Intel[®] Pentium[®] 4 Processor Specification Update

Release Date: March 2002

Order Number: 249199-020

The following figure will be added as Figure (new). THERMTRIP# Power Down Sequence

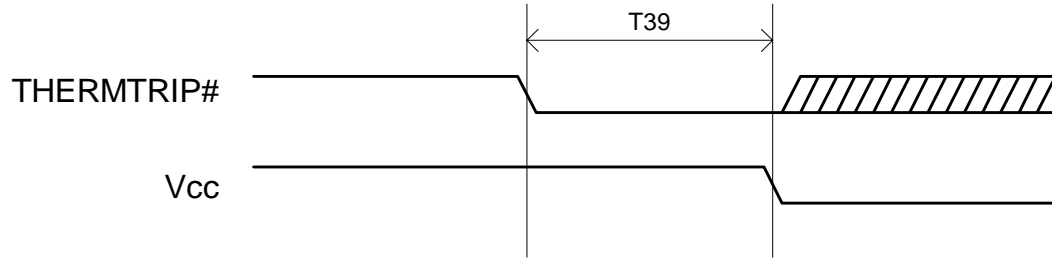
N3. THERMTRIP# Clarification

Several parts of the *Intel® Pentium® 4 Processor in the 423-pin Package* datasheet will be updated as follows to clarify the functionality of the Thermtrip# pin.

The following specification will be added to Table 13, page 24.

<u>T# Parameter</u>	<u>Min</u>	<u>Max</u>	<u>Unit</u>	<u>Figure</u>	<u>Notes</u>
T39: THERMTRIP# to removal of power	N/A	500	ms	(new)
